**MONTGOMERY COUNTY HISTORIC PRESERVATION COMMISSION**  
**STAFF REPORT**

<b>Address:</b>	7 W. Kirke, Chevy Chase	<b>Meeting Date:</b>	9/6/2023
<b>Resource:</b>	Contributing Resource <b>Chevy Chase Village Historic District</b>	<b>Report Date:</b>	8/30/2023
<b>Applicant:</b>	Marc & Lena Katz Setphanie Fisher, Agent	<b>Public Notice:</b>	8/23/2023
<b>Review:</b>	HAWP	<b>Tax Credit:</b>	N/A
<b>Permit Number:</b>	103938 & 1040852	<b>Staff:</b>	Dan Bruechert
<b>Proposal:</b>	Hardscape Alteration, EV Charger Installation, Water Feature Installation

## HARDSCAPE PLAN

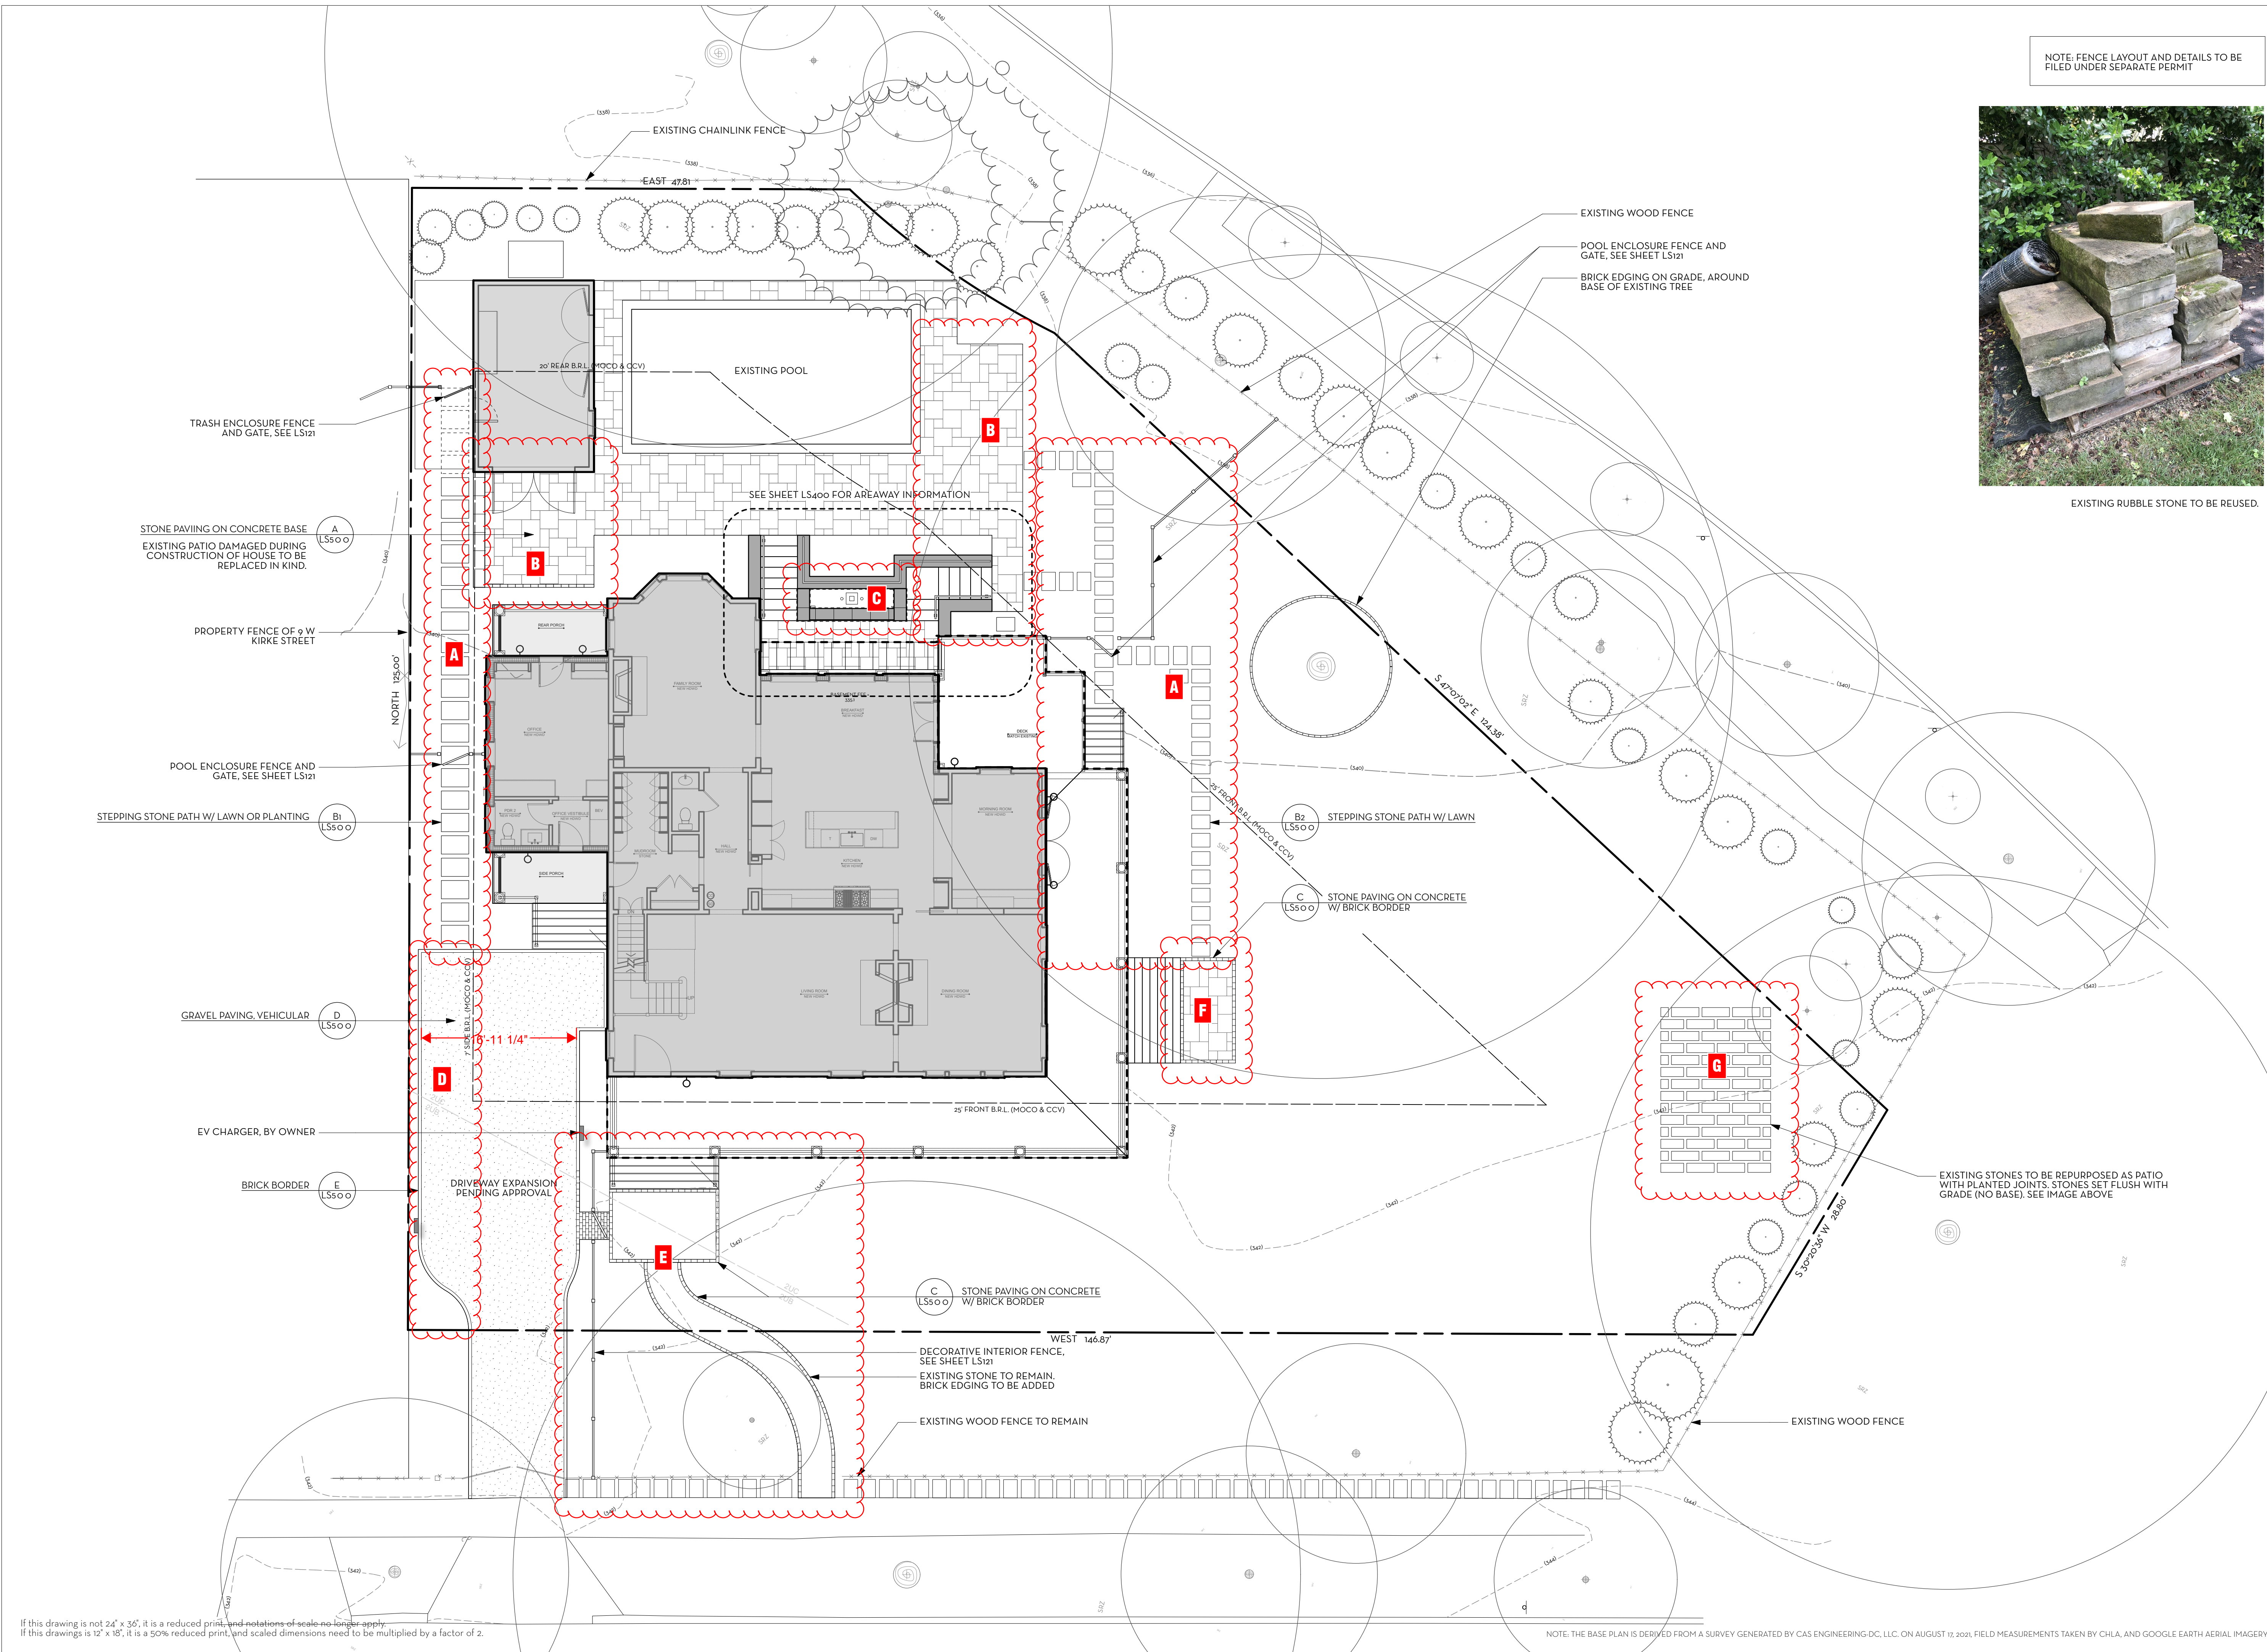
1. Installing steppingstones along the west property line from the end of the driveway to the rear trash enclosure;
2. Expand the existing pool deck including constructing stone stairs and iron railing;
3. Construct a fountain/water feature at the rear of the house adjacent to the pool area;
4. Relocate the pool equipment approximately 5' (five feet) to the east;
5. Widen the gravel driveway from 10' (ten feet) to 18' (eighteen feet);
6. Construct a brick walk from the driveway to the landing at the base of the front porch stairs and add a brick edging to the existing front walkway;
7. Construct a landing at the base of the east side porch stairs; and,
8. Construct a patio using reclaimed stones in the southeast corner of the lot.

Staff finds the proposed steppingstones, which include lawn or planting between the stones, will add to the hardscaping, but because they are on grade behind the driveway, the stones will not have a significant visual impact on the character of the site or surrounding district. Staff finds the material is appropriate and does not detract from the resource as required under a moderate scrutiny review.

Staff finds the expanded stone pool decking, to the east of the pool, and the new stairs, to the south of the pool, will not have a significant impact on the character of the site or the surrounding district. The stones will match the existing patio and Staff finds are compatible with the character of the house and surrounding district. Staff additionally finds the simple iron railing will not detract from the character of the site and is the least obtrusive design for an element that is required by the building code. Staff finds this work satisfies the requirement of a moderate scrutiny review and recommends the HPC approve the alterations to the pool decking and rear stairs.

At the rear of the lot, in the northwest corner, the applicant proposes to relocate the pool equipment approximately 5' (five feet) to the east. Because of the privacy fencing in this location, the equipment

The existing gravel driveway is approximately 10' (ten feet wide) and runs from the sidewalk to the rear of the front porch. The applicant proposes to widen the driveway to 18' (eighteen feet) and install a brick border. Staff finds the expanded driveway will reinforce the material and texture of the existing driveway while accommodating two cars parking off-street. Staff finds the materials are consistent with the existing driveway and the expanded driveway will not add any impermeable surface to the site. Staff recommends the HPC approve the driveway expansion.

Between the driveway and the existing front porch landing, the applicant proposes to install a brick walkway that measures approximately 3' × 3' (three feet by three feet). This walkway creates a paved connection between the two spaces. Staff finds the size and materials are appropriate and recommends the HPC approve the new walk. In addition to the brick walk, the applicant proposes to install a brick edge to the existing front walkway. Staff finds the brick is an appropriate material and the added paving is de minimis and will not have a significant impact on the character of the house or surrounding district. Staff also notes the brick will match the appearance of the existing brick sidewalk, and that the border may better tie the house to the right-of-way creating a more compatible appearance.

At the east side of the wrap-around porch stairs, the applicant proposes to install a flagstone landing. Currently, there is only lawn at the foot of these stairs. The proposed landing will measure approximately 5' × 10' (five feet by ten feet) and have a brick border. Staff finds the proposed landing is compatible with the house materials and other hardscaping on site. Staff recommends the HPC approve the landing under the *Design Guideline* for sidewalks.

The final hardscaping element proposed is to construct a patio near the southeast corner of the lot. The patio measures approximately 15' × 20' (fifteen feet by twenty feet) and will be constructed using reclaimed and repurposed stones from the site. The stones will be dry-laid and will section of lawn or plantings between the stones. Staff finds the proposed patio will not impact any trees on site and additionally finds the proposed stones are appropriate.

Staff finds the cumulative effect of the hardscaping to be compatible with the character of the site and surrounding district. Staff additionally finds the proposed work will not impact any mature trees on site, which would trigger a strict scrutiny review of the work proposed. While Staff finds the work to be appropriate, Staff would not support additional hardscaping on site as additional paving, even permeable paving, may begin to detract from the district's "remarkable park-like setting." Staff recommends the HPC approve the hardscaping under the *Design Guidelines*, 24A-8(b)(2) and (d), and Standards 2, 9, and 10.
